Field Service Action 22S06

SUBJECT: 22S06 – MUSTANG

Luggage Compartment Lid Wiring Inspection and Rear View Camera Improper Function

22S06: Mustang – Luggage Compartment Lid Wiring Inspection and Rear View Camera Improper Function – NEW VEHICLE DEMONSTRATION / DELIVERY HOLD – Safety Recall

FIGURE 1

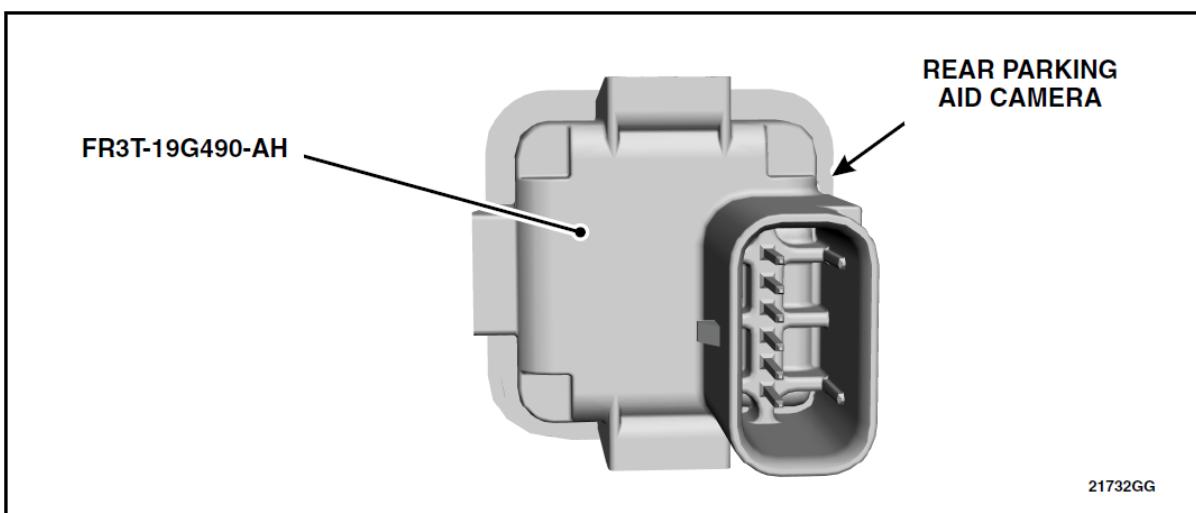
3. With the rear parking aid camera out of the vehicle, inspect the engineering part number on the back of the camera. See Figure 1.

Is the part number FR3T-19G490-AH?

Yes	Reinstall the Rear Parking Aid Camera. Please follow the WSM procedures in Section 413-13B. Do not install the luggage compartment lid trim at this time. Proceed to Step 4.
No	Replace the Rear Parking Aid Camera. Please follow the WSM procedures in Section 413-13B. Do not install the luggage compartment lid trim at this time. Proceed to Step 4.

FIGURE 15

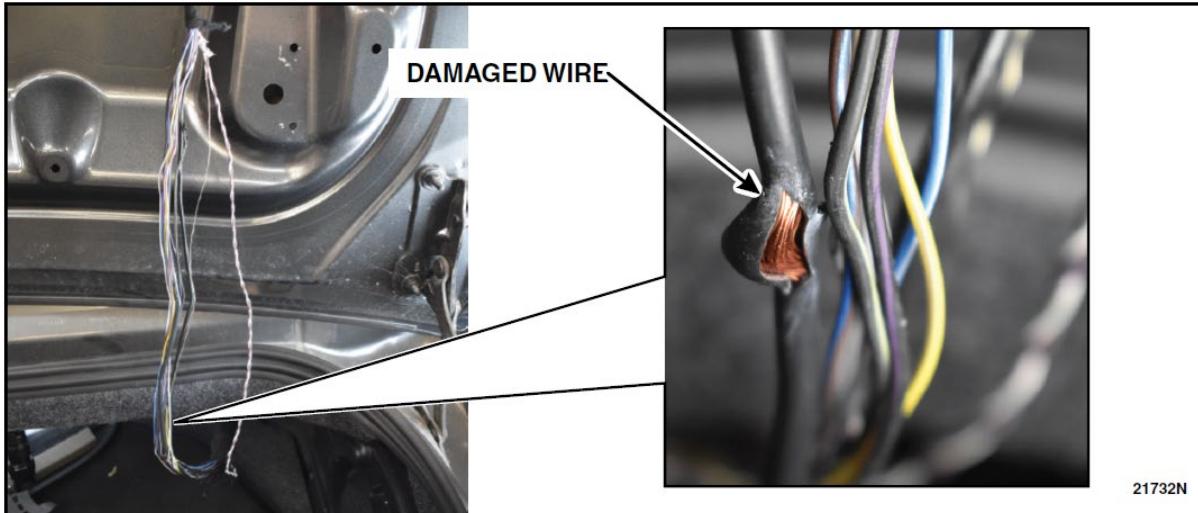
19. Inspect the entire exposed portion of the wiring harness for any sign(s) of damage or chafing. See Figure 14.

Is any damage or chafing found?

NOTE: One example of wiring damage, others similar.

Yes	Proceed to Step 20 .
No	Proceed to Coupe Harness - Repair Parts Needed then Step 26 .

FIGURE 16

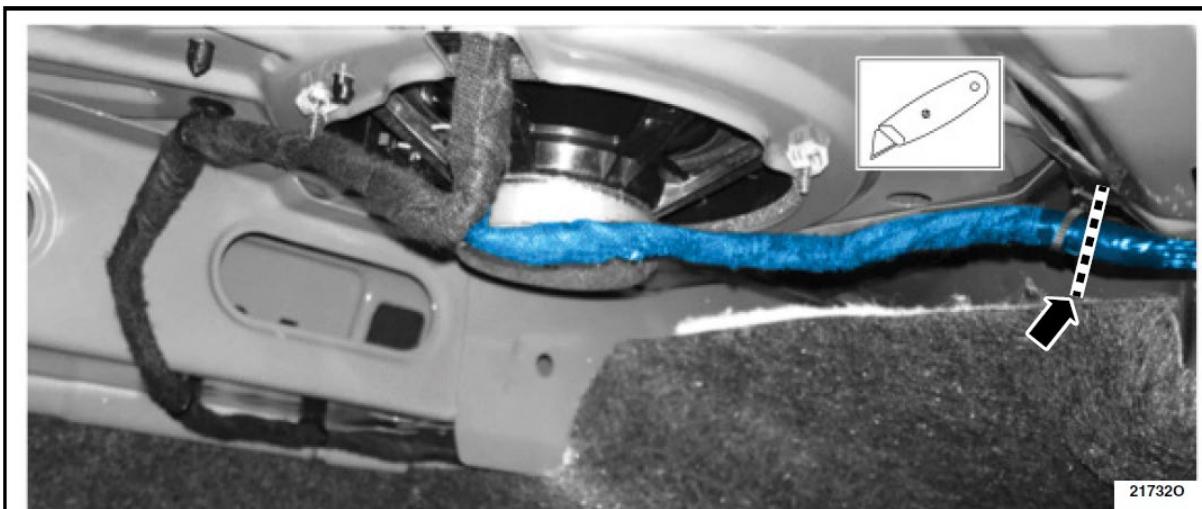
20. Cut out the damaged section of the harness. Make the cut at the location of the harness noted. See Figure 16.

21. Splice in the new section of harness, matching wire colours on the existing vehicle harness and the replacement section of harness as necessary. Follow the recommended wiring splice procedures in Section 5 of the Wiring Diagram using solder, not wire crimps. Stagger the location of each of the wire splices along the harness to minimize the overall size of the repair.

FIGURE 19

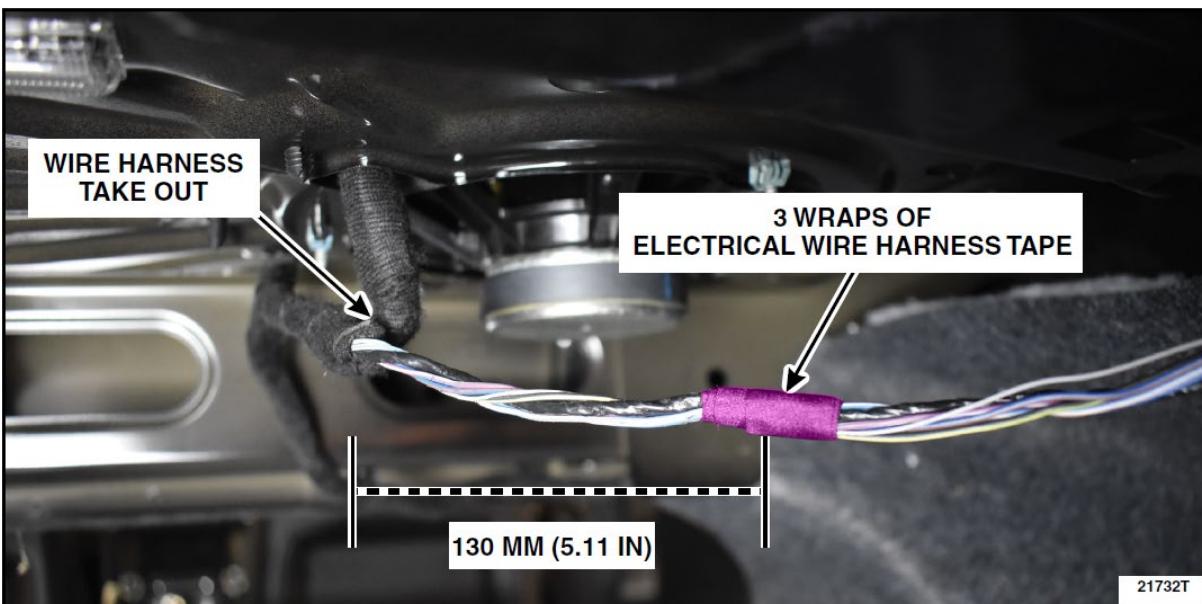
28. Measure 130 mm (5.11 in) from the wire harness take out. Apply 3 wraps of Coroplast® 837 or equivalent electrical wire harness tape around the wiring harness. See Figure 19.

FIGURE 20

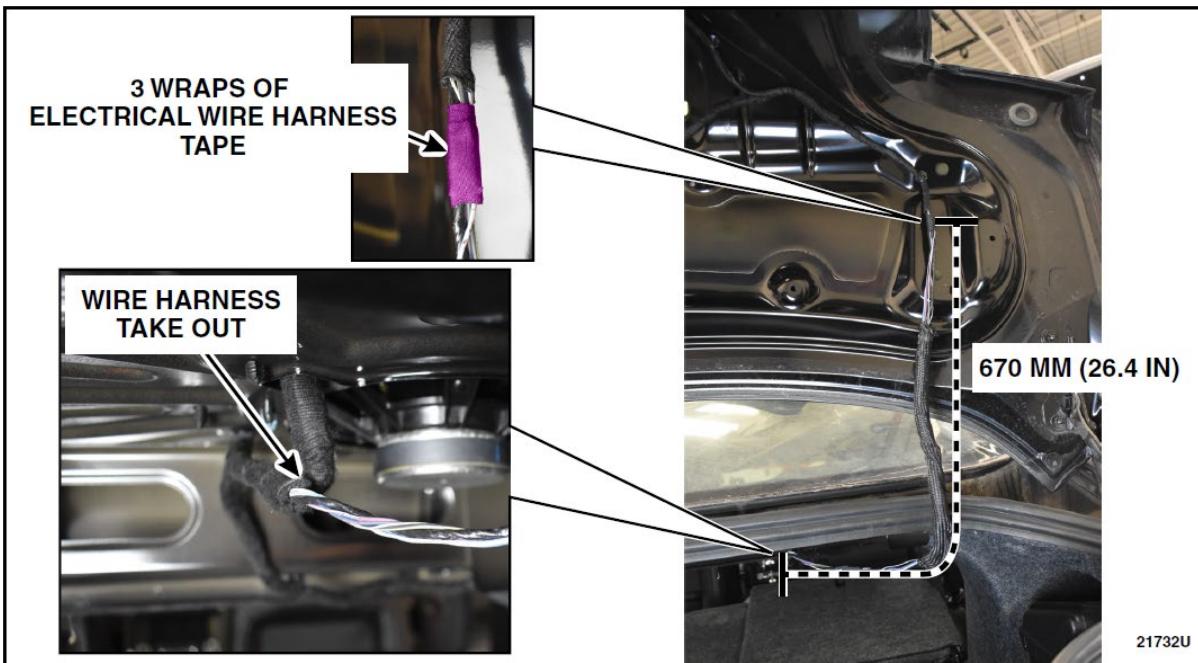
29. Measure 670 mm (26.4 in) from the wire harness take out. Apply 3 wraps of Coroplast® 837 or equivalent electrical wire harness tape around the wiring harness. See Figure 20.

FIGURE 22

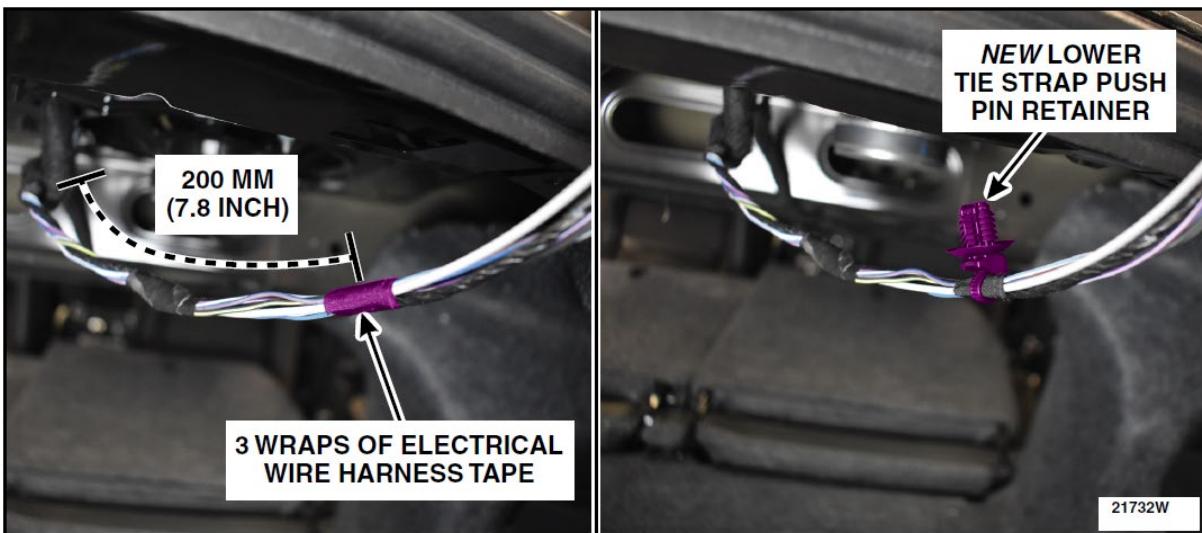
31. Measure 200 mm (7.8 in) from the wire harness take out. Apply 3 wraps of Coroplast® 837 or equivalent electrical wire harness tape over the harness and support stick. Install a new lower tie strap push pin retainer mid way onto the electrical wire harness tape. Trim any excess from the tie strap. See Figure 22.

FIGURE 24

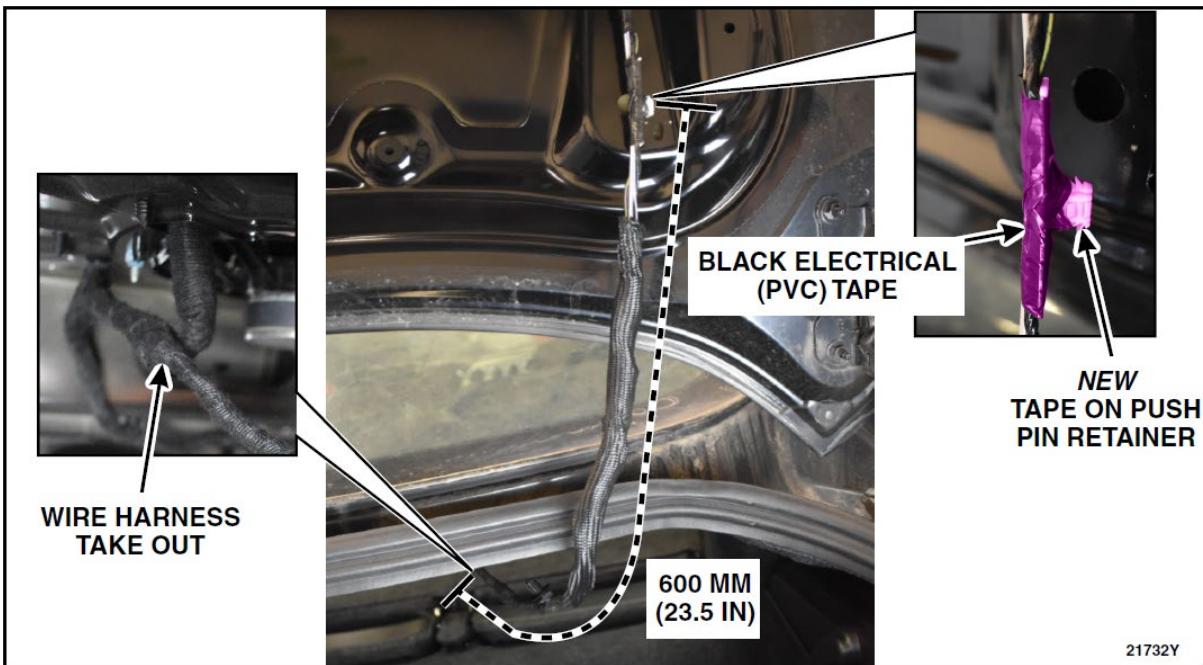
33. Measure 600 mm (23.5 in) from the wire harness take out, install the new tape on push pin retainer using some KTI73510 or equivalent black electrical (PVC) tape. See Figure 24.

FIGURE 39

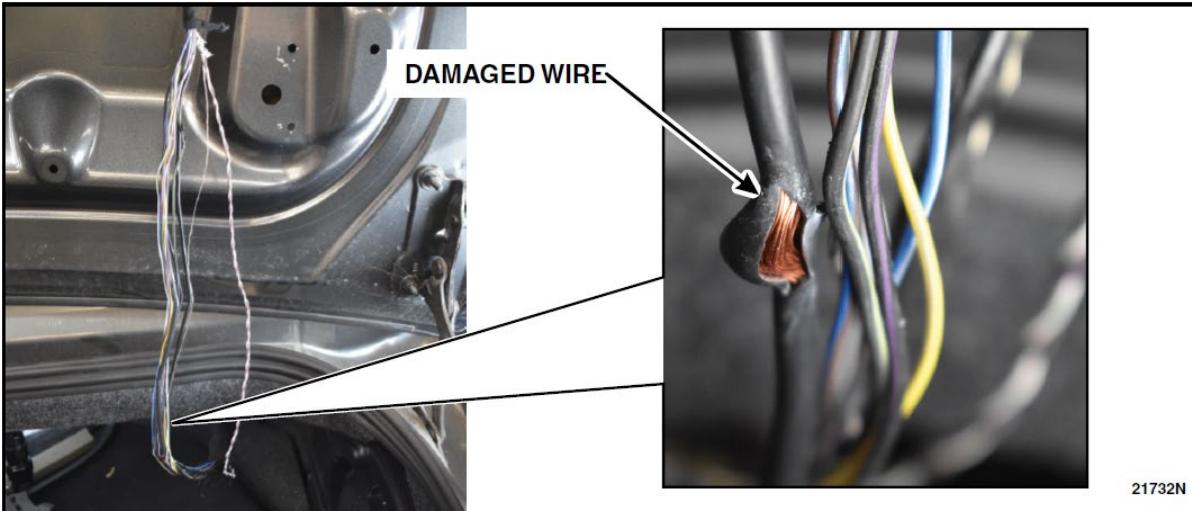
52. Inspect the entire exposed portion of the wiring harness for any sign(s) of damage or chafing. See Figure 39.

Is any damage or chafing found?

NOTE: One example of wiring damage, others similar.

Yes	Proceed to Step 53.
No	Proceed to Convertible Harness - Repair Parts Needed then Step 61.

FIGURE 40

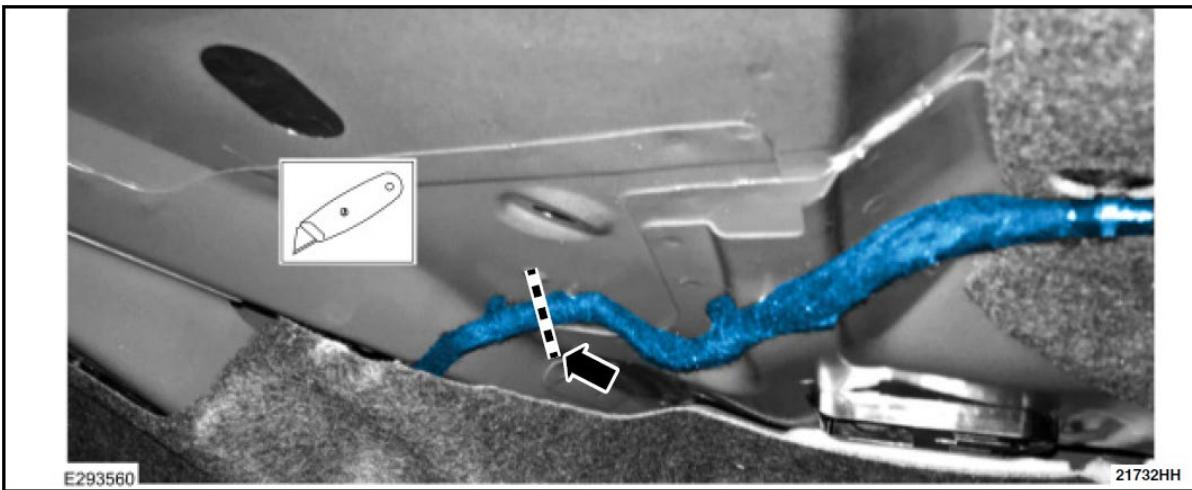
53. Cut out the damaged section of the harness. Make the cut after the ground wire (front of vehicle side of harness) at the location of the harness noted. See Figure 40.

54. Splice in the new section of harness, matching wire colours on the existing vehicle harness and the replacement section of harness as necessary. Follow the recommended wiring splice procedures in Section 5 of the Wiring Diagram using solder, not wire crimps. Stagger the location of each of the wire splices along the harness to minimize the overall size of the repair.

FIGURE 41

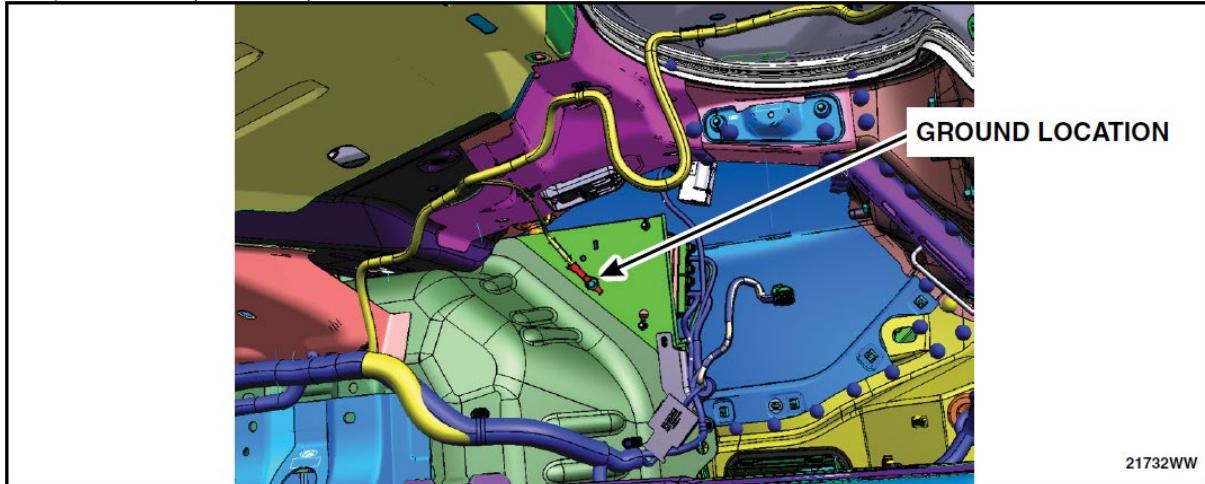
55. Remove the existing ground on this section of the harness from the body of the vehicle. Reinstall the ground on the new section of harness to the body of the vehicle. See Figure 41.

- If equipped, remove the subwoofer. Please follow the WSM procedures in section 415-00B.
- If there is no existing bolt, use electrical ground bolt W505255-S450L self-threading bolt.
- Torque: 12 Nm (106 lb. in).

FIGURE 44

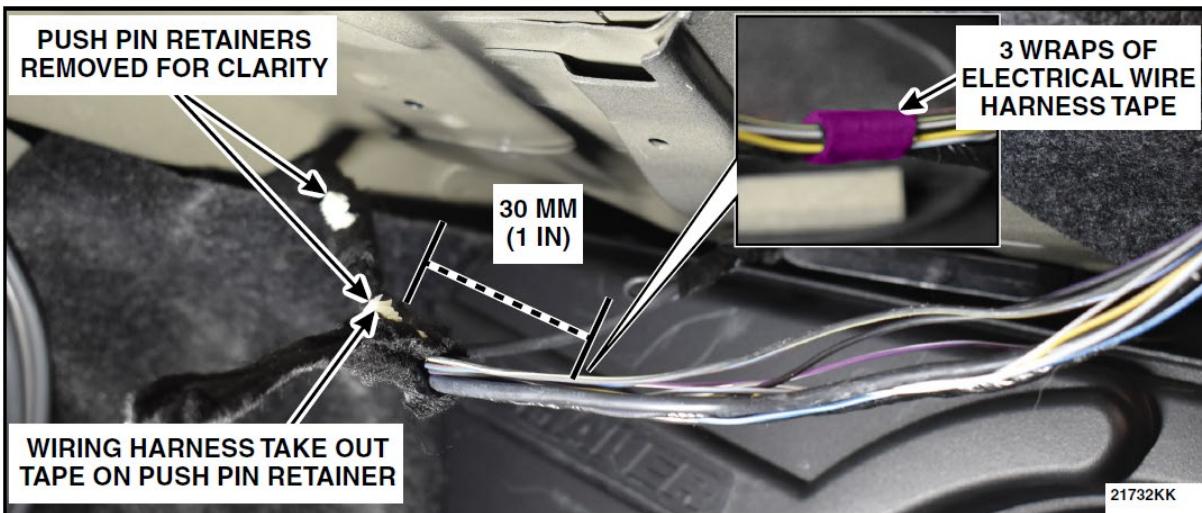
63. Measure 30 mm (1 in) from the wiring harness take out tape on push pin retainer. Apply 3 wraps of Coroplast® 837 or equivalent electrical wire harness tape around the harness. See Figure 44.

FIGURE 45

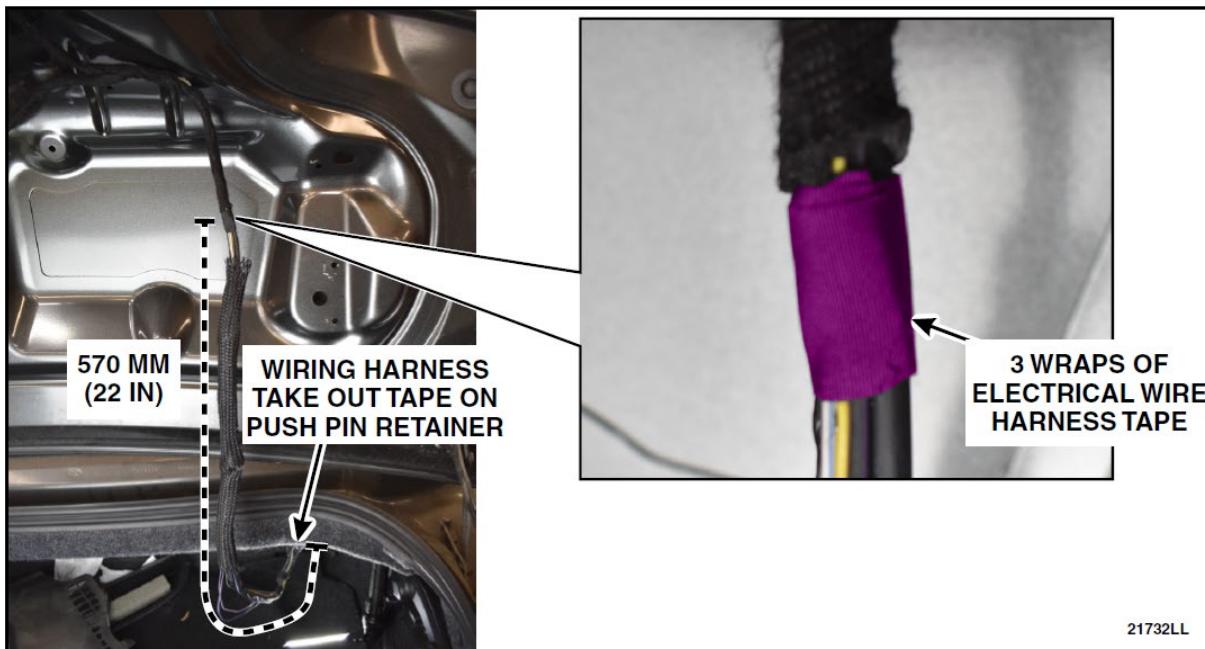
64. Measure 570 mm (22 in) from the wiring harness take out tape on push pin retainer. Apply 3 wraps of Coroplast® 837 or equivalent electrical wire harness tape around the harness. See Figure 45.

FIGURE 47

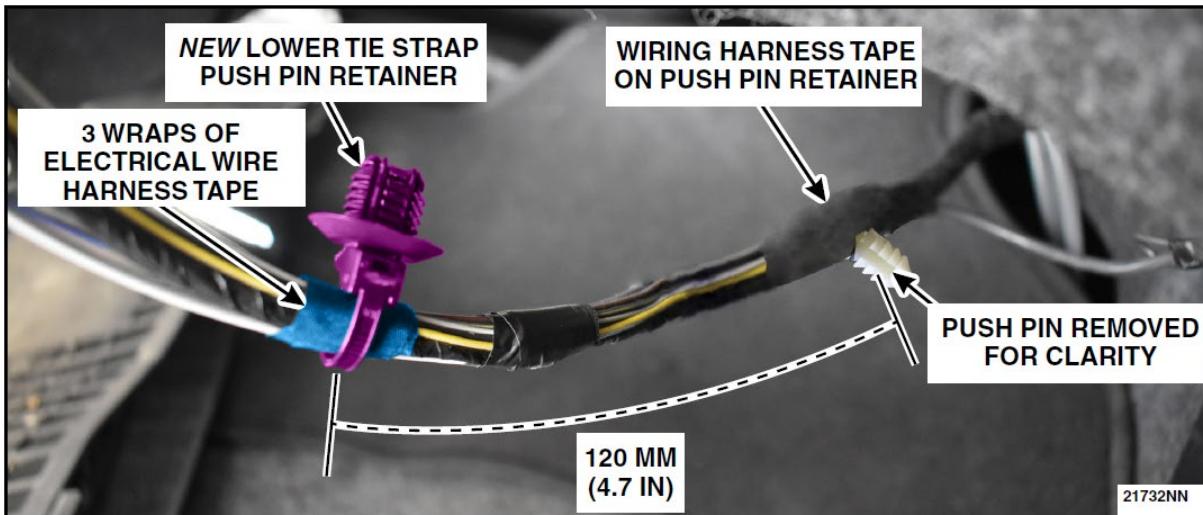
66. Measure 120 mm (4.7 in) from the wiring harness tape on push pin retainer and apply 3 wraps of Coroplast® 837 or equivalent electrical wire harness tape. Install a new lower tie strap push pin retainer mid way onto the electrical wire harness tape. Trim any excess from the tie strap. See Figure 47.

FIGURE 50

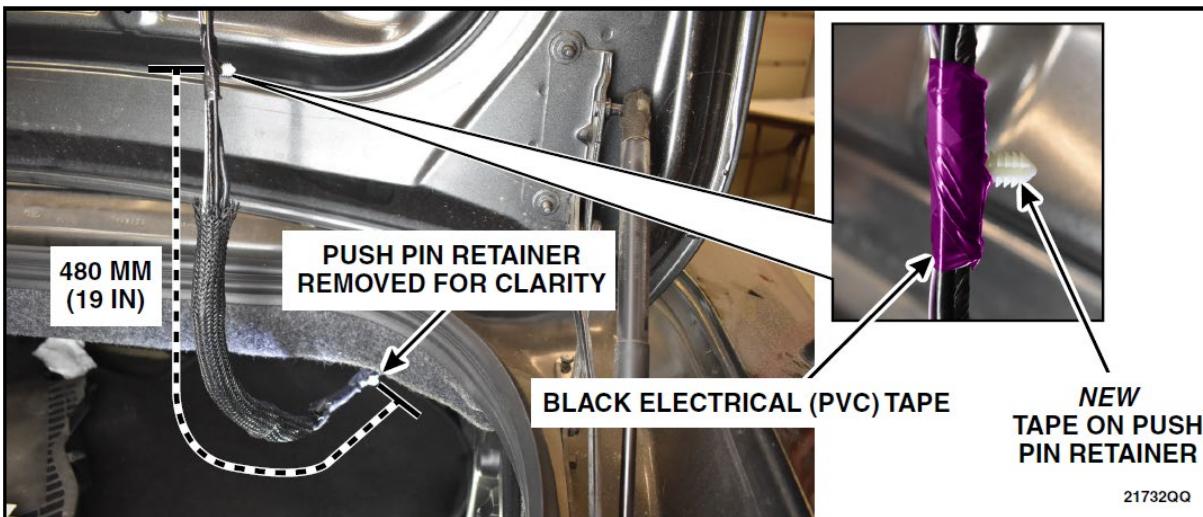
69. Measure 480 mm (19 in) from the wiring harness take out tape on push pin retainer and install a new tape on push pin retainer using some KTI73510 or equivalent black electrical (PVC) tape. See Figure 50.

FIGURE 52

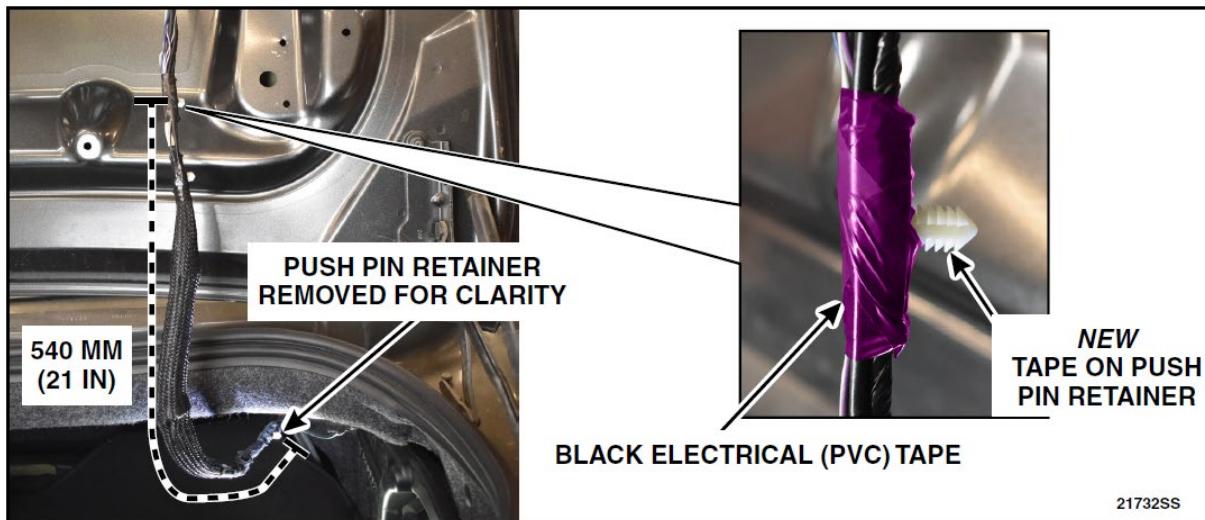
71. Measure 540 mm (21 in) from the wiring harness take out tape on push pin retainer and install a new tape on push pin retainer using some KTI73510 or equivalent black electrical (PVC) tape. See Figure 52.
